601 North II Stream Restoration Site

Annual Monitoring Report
NCDMS Project Number: 95025
Monitoring Contract Number: 003991
Monitoring Year 5 2017

RE: 601 North II Stream Restoration Site: MY5 Monitoring Report (NCDMS ID 95025)

Listed below are comments provided by DMS on January 16, 2018 regarding the 601 North II Stream Restoration Site: Year 5 Monitoring Report and RES' responses.

Figure 2
601 North II Stream
Restoration Project
MY5 2017

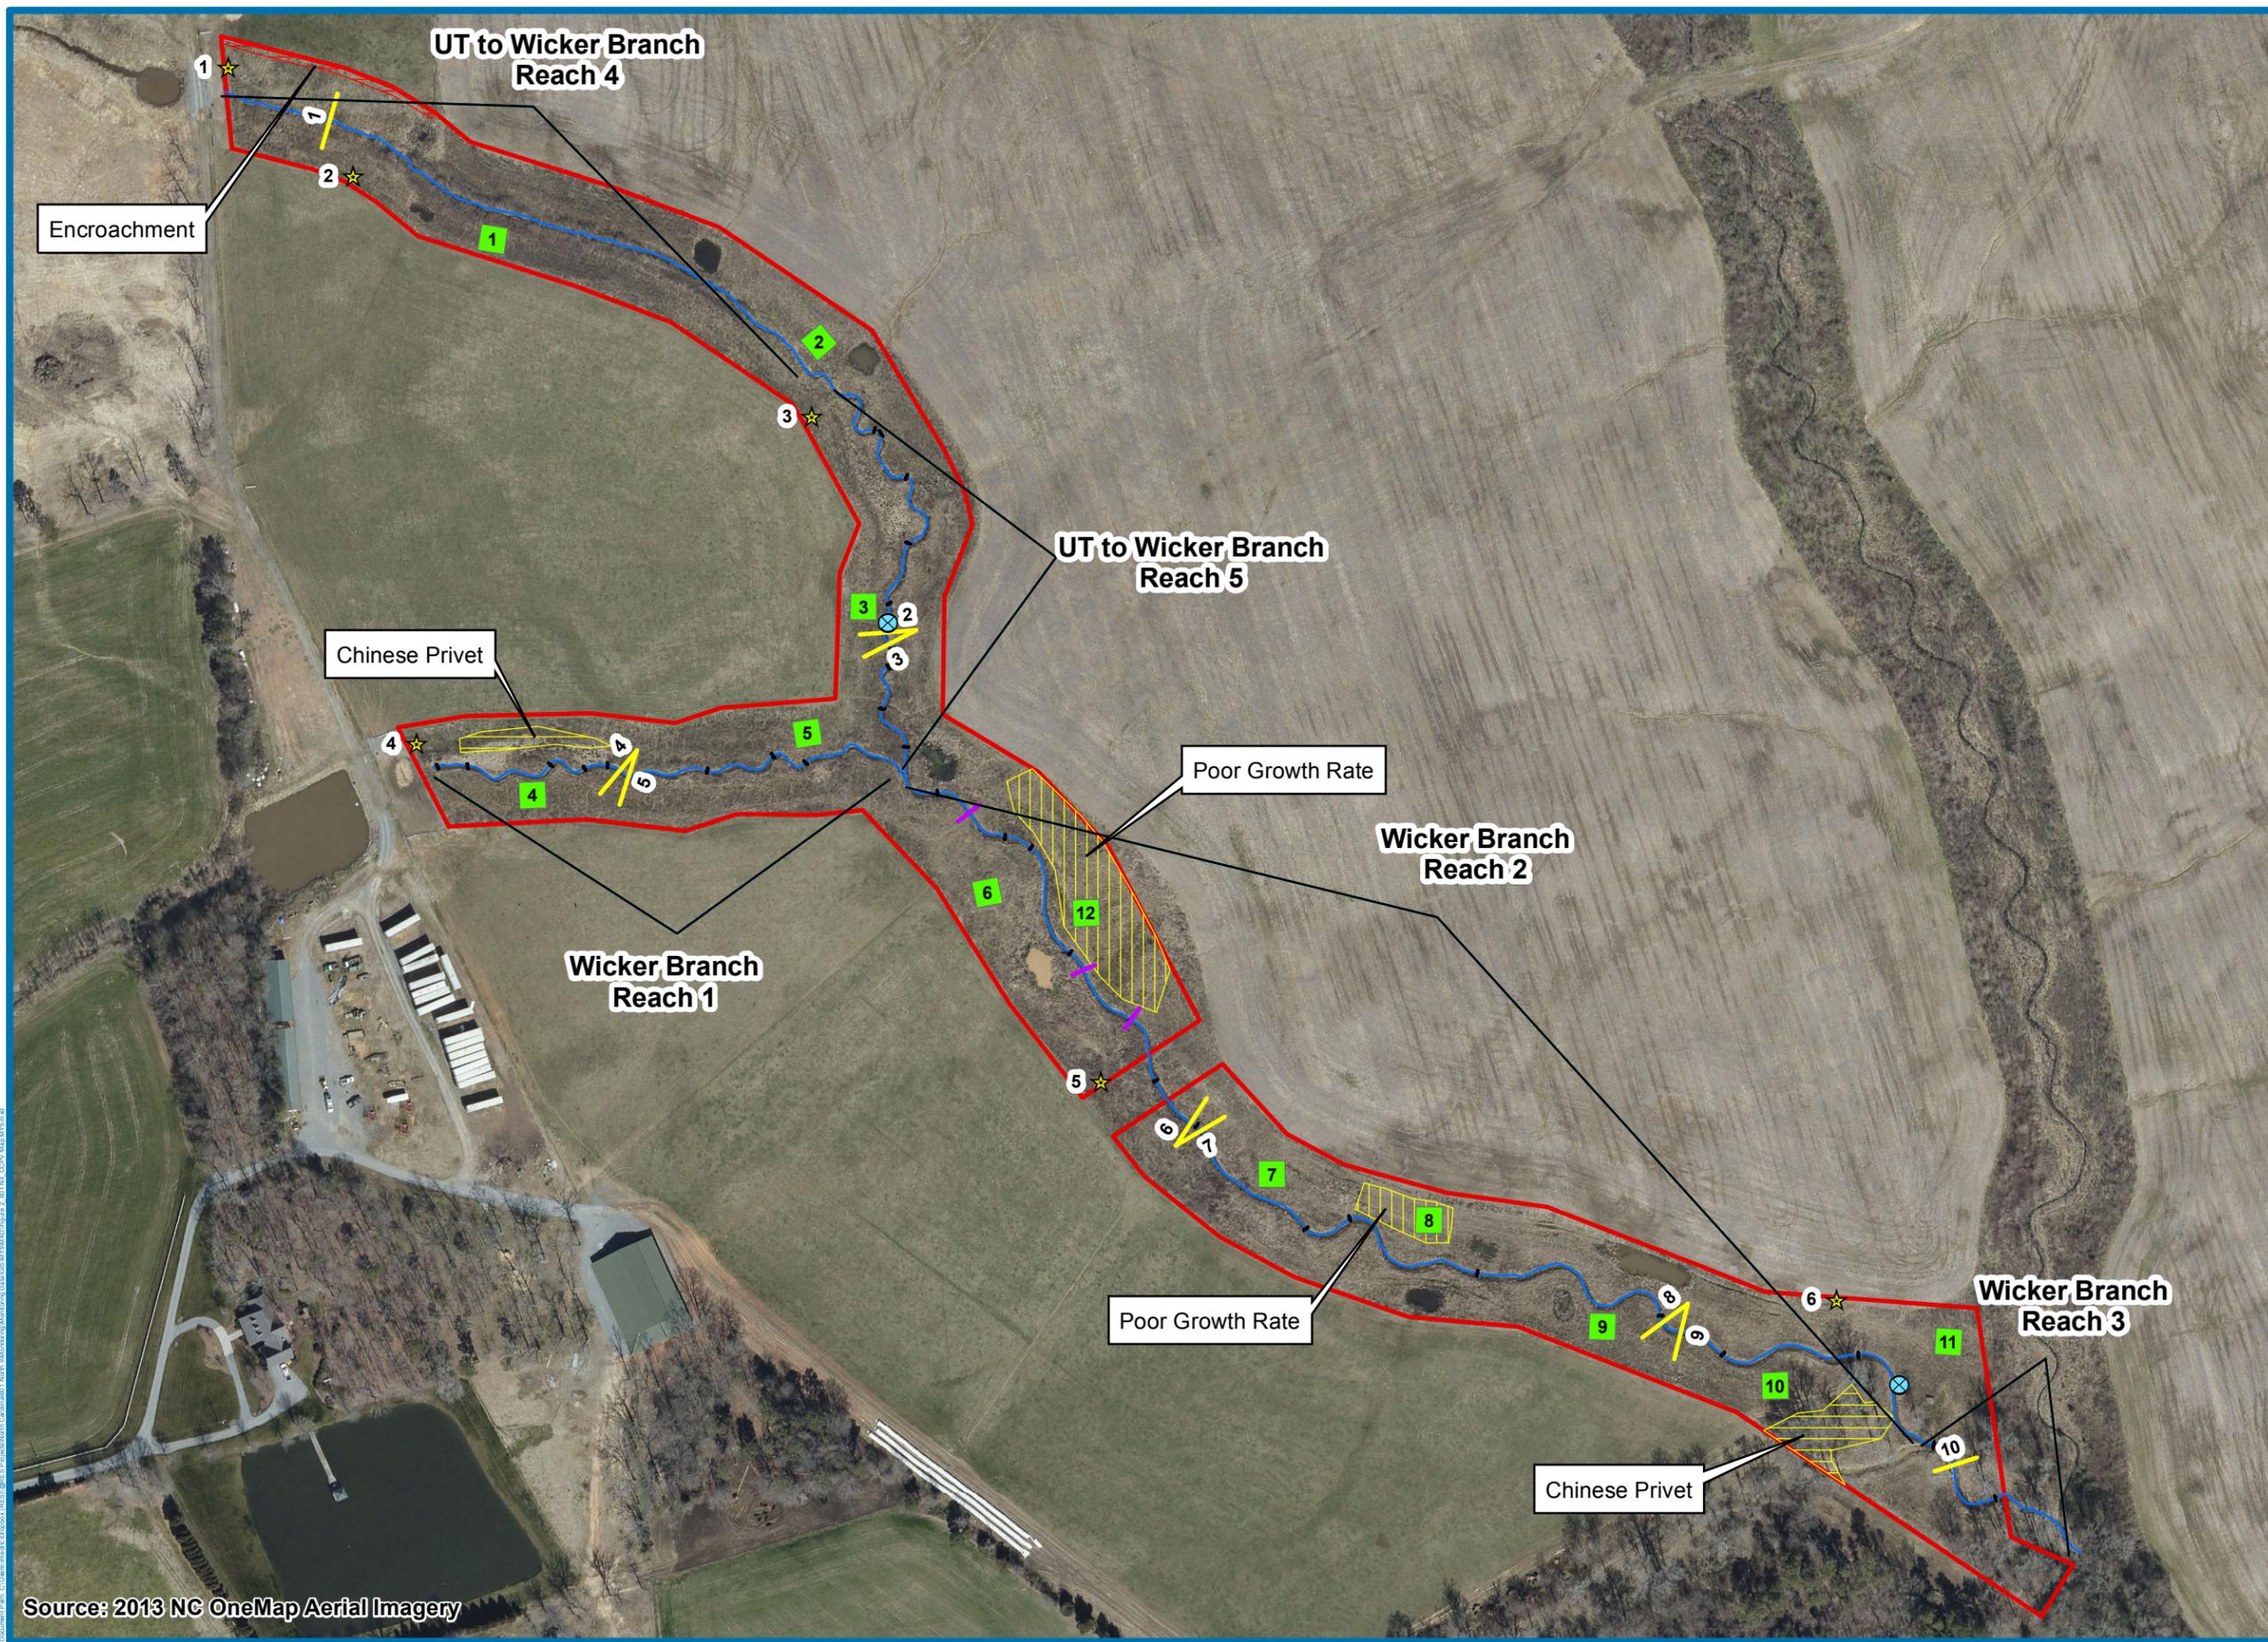
An encroachment is discussed on Reach 4 between sta: 0+00 and 1+50. This encroachment has occurred more than once during the life of the project. No solution or corrective measure is discussed regarding the encroachment. What has RES done to prevent further encroachment? Please update section to discuss corrective measure. If the encroachment cannot be resolved, please inform DMS for assistance. Please be aware that historic encroachments may prevent the project from being accepted by stewardship thereby preventing closeout.

RES plans to lock the gate that is being used to access the easement. Then RES will install a new gate outside the of easement to allow the farmer access to the other field without having to cut through the easement.

Figure 5. Cross Section Plots and Photos

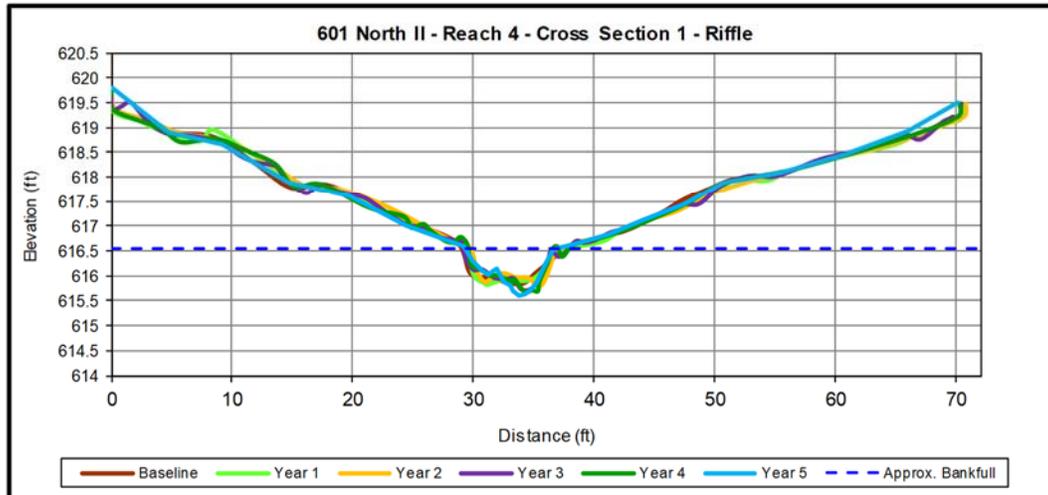
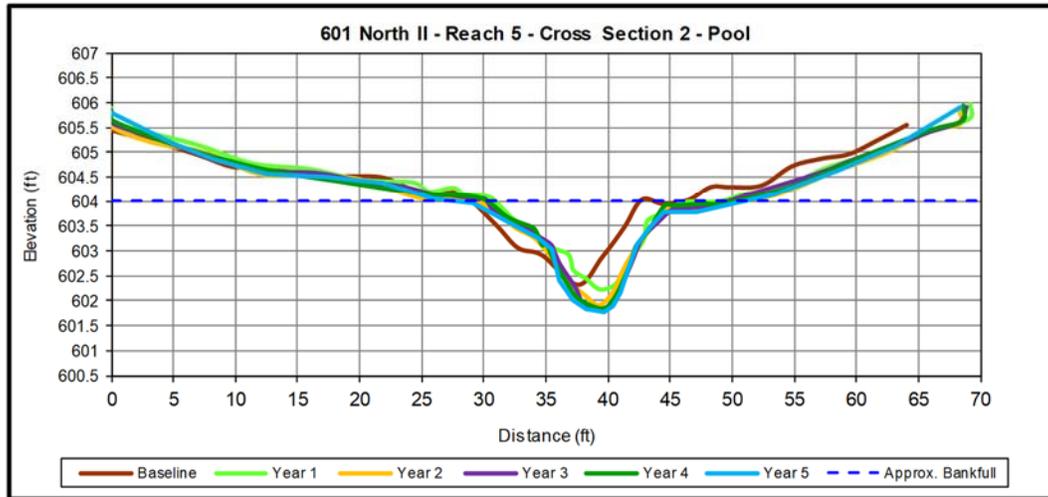
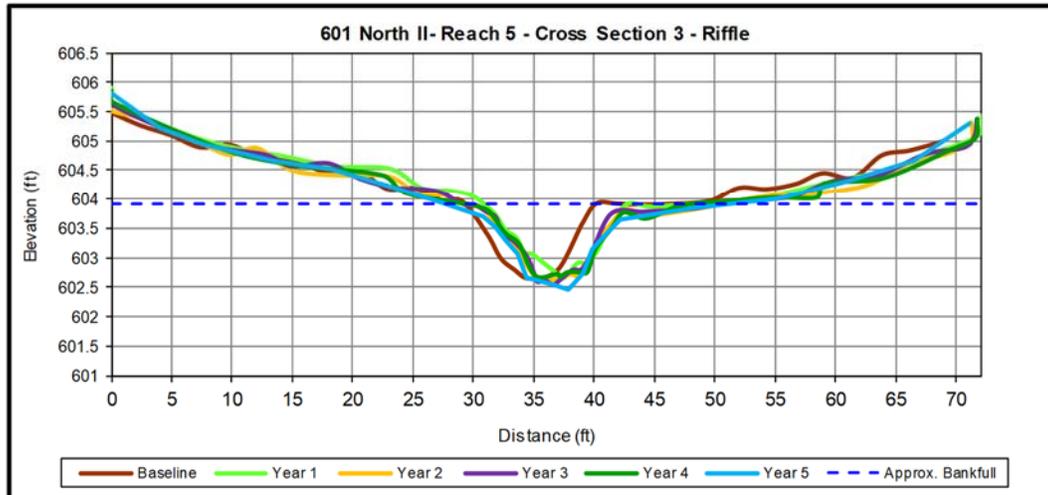
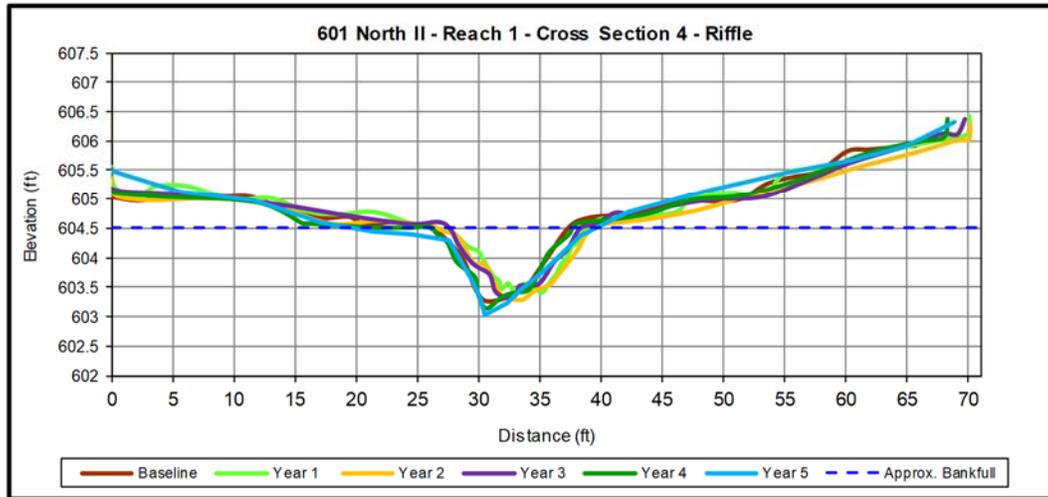
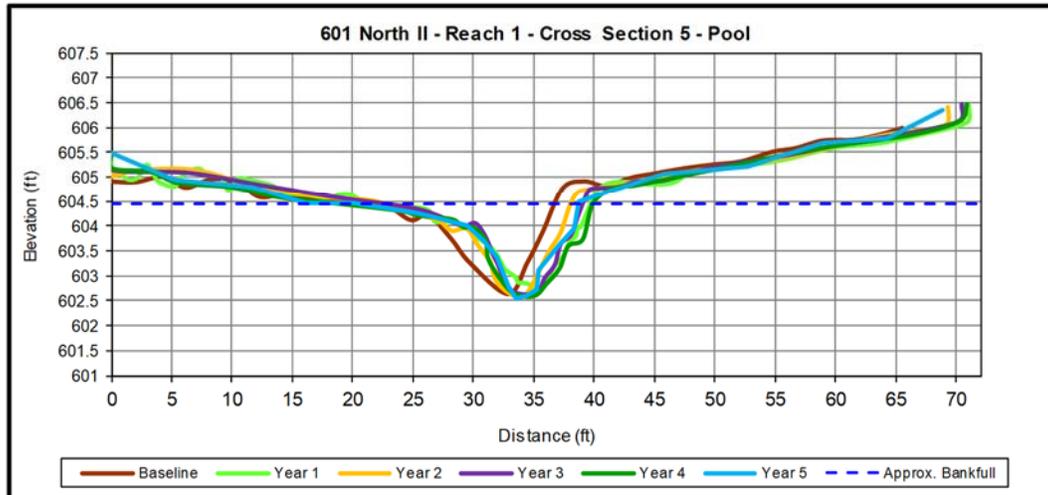
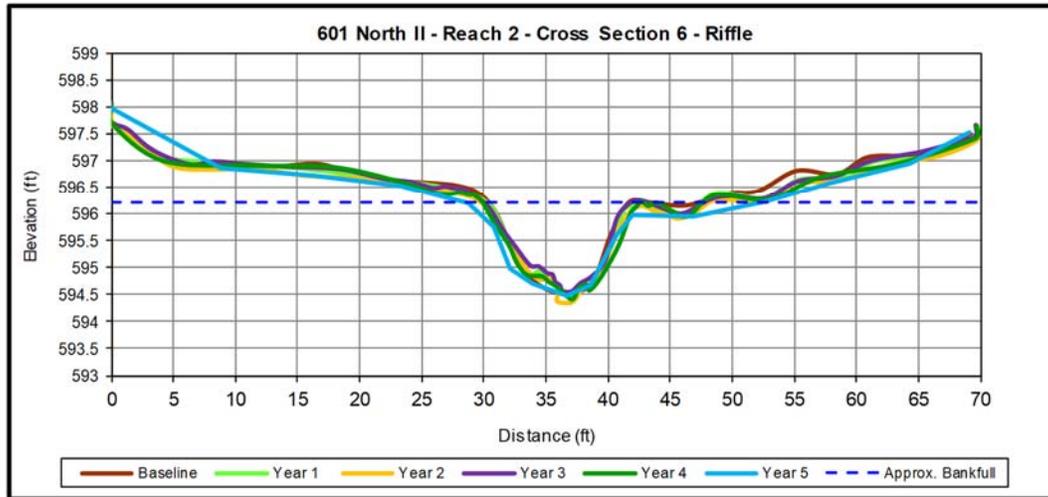
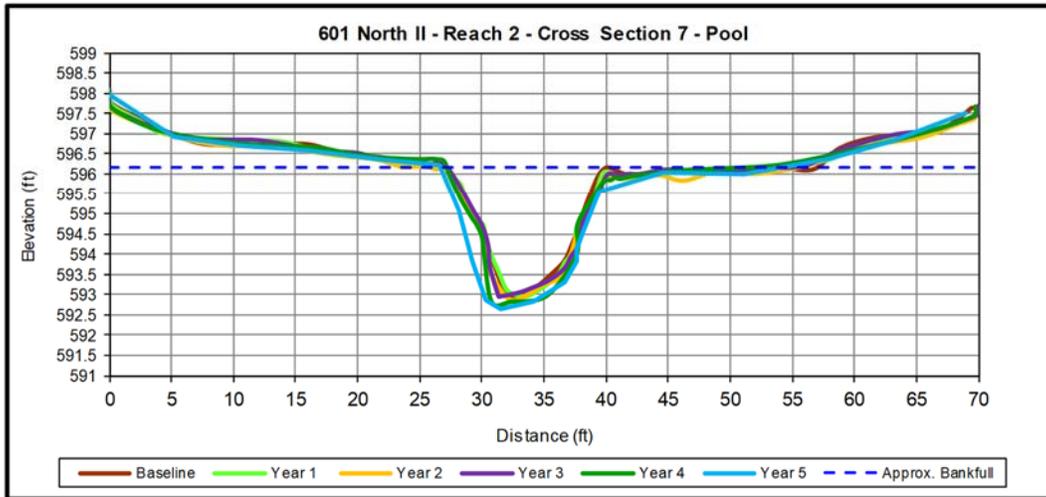
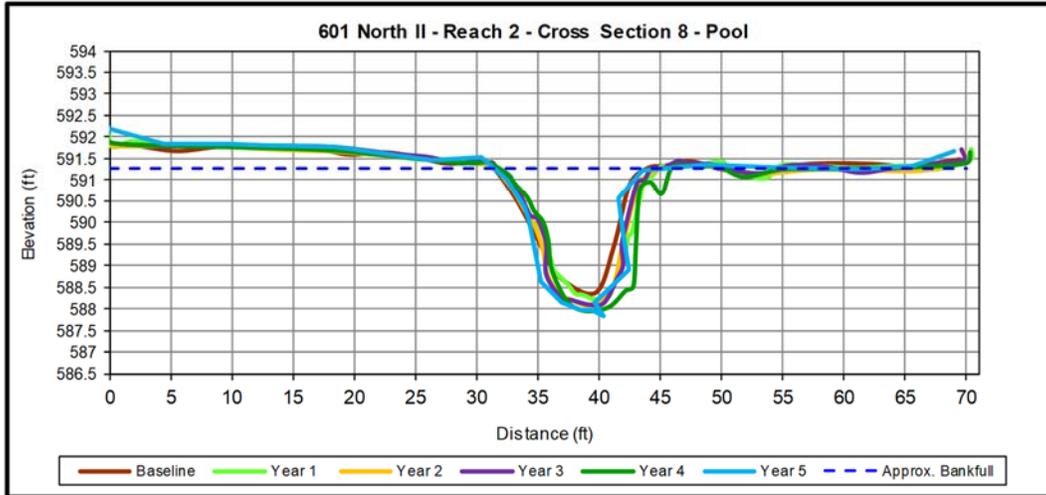
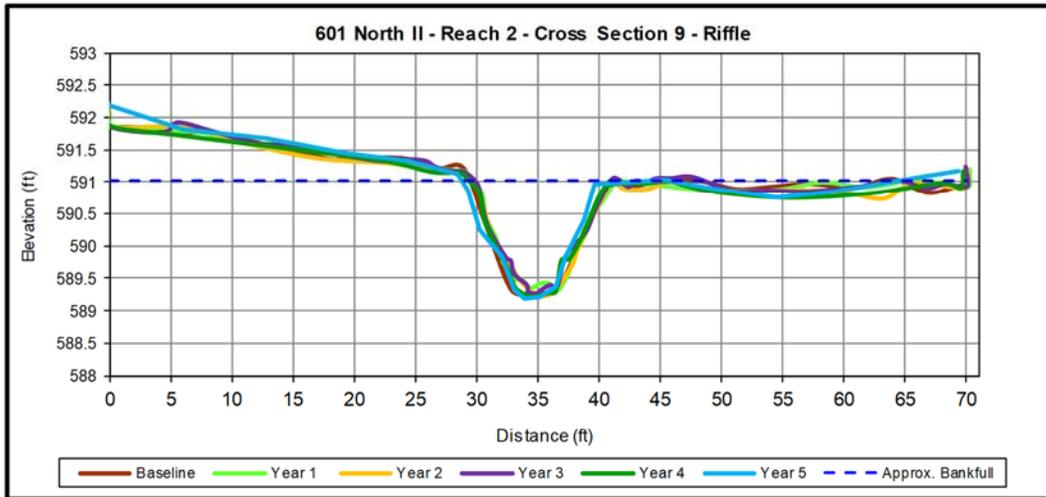
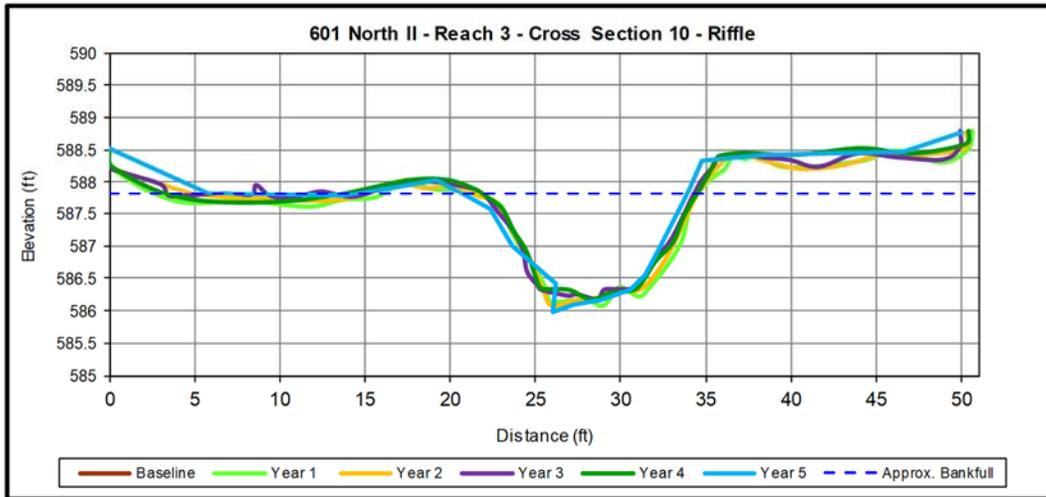
The IRT has expressed concern with having a BHR of 1.0 for all monitoring years. The IRT has requested that Bank Height Ratios be calculated. Please calculate BHR for cross sections and update Table 11. If BHR has been calculated, consider increasing the significant digits to show changes throughout monitoring years (example: 1.06). Also, be prepared to discuss with the IRT how RES calculates BHR at the Credit Release meeting.

BHR for MY5 riffle cross sections has been calculated using the bankfull elevation from baseline. This method was used because the dimension of the channels has not changed enough to alter the bankfull elevation. BHR from previous years was not calculated therefore it is not included. This has been added to the report and as a footnote to Table 11a.
